Docket Item #19
DEV. SPECIAL USE PERMIT #2007-0023

Planning Commission Meeting
September 6, 2007

ISSUE: Consideration of a request for an amendment to allow information and sales trailers and a request for an amendment to permit additional roof decks and garage decks in Landbay H and partial Landbay I, and to revise condition #1E regarding pedestrian crossings.

Figure 1. Comparison of Approved and Revised Garage

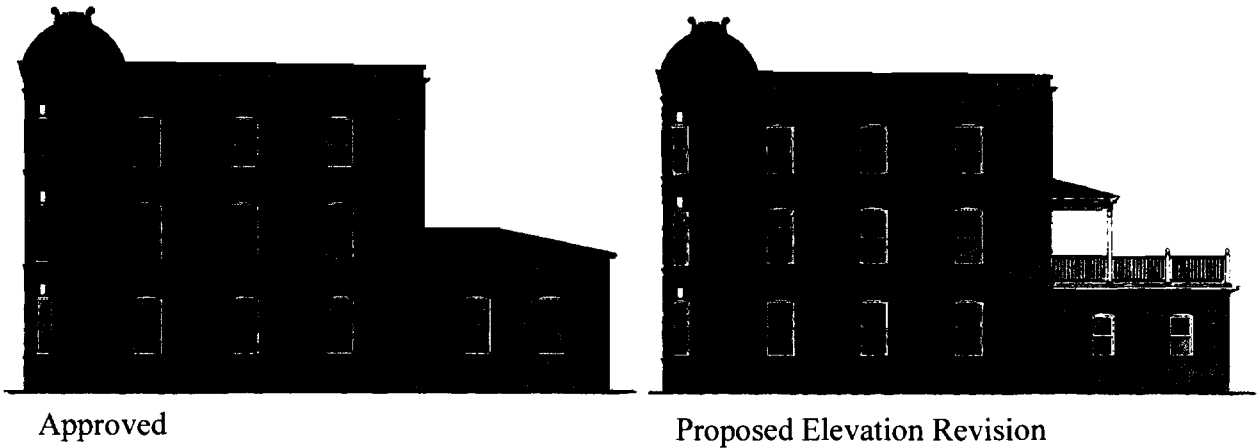
As part of the final site plan review, the applicant proposed adding a deck/porch over the garages. Staff supports this proposal, because the terrace/porches will provide additional open space for the individual townhouses, but will also enhance the pedestrian environment by activating the alley entrances off the streets and the building design of each unit. The rear terraces/porches have historic precedent (unlike the roof-top decks), therefore, unlike the roof terraces, staff does not have concern about the visibility of these garage decks from the street or public areas.

Similar to the roof terraces, high quality materials and design will be required for these garage terraces, especially because they are visible from the street. But unlike the roof terraces, which are discouraged to be located on units visible from the streets, the garage decks are encouraged to be visible from the streets since these add people activity and architectural interest within the alleys or for some of the corner units. There are six locations where this condition will be possible. The same lighting condition required of the roof terraces will apply to the garage decks.

Figure 2: Temporary Information and Sales Trailers

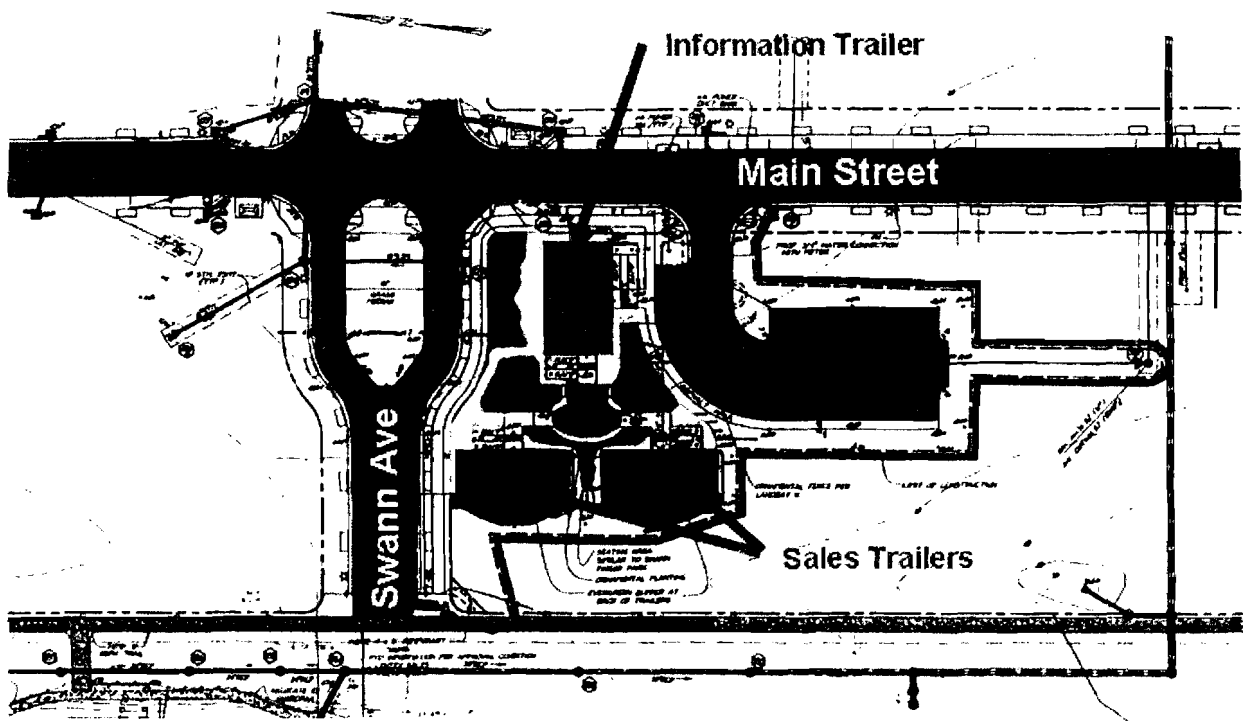
Staff is recommending approval of the temporary sales trailers, which are necessary for a project of this size predicated on the following:

- a. The trailers be permitted for a maximum of 20 months from the date of the final site plan approval;
- b. The proposed size, location and design of the signage for the sales trailer and freestanding signage shall be to the satisfaction of the Director of P&Z.
- c. Landscaping be provided adjacent to the trailers and evergreen shrubs to screen the surface parking.
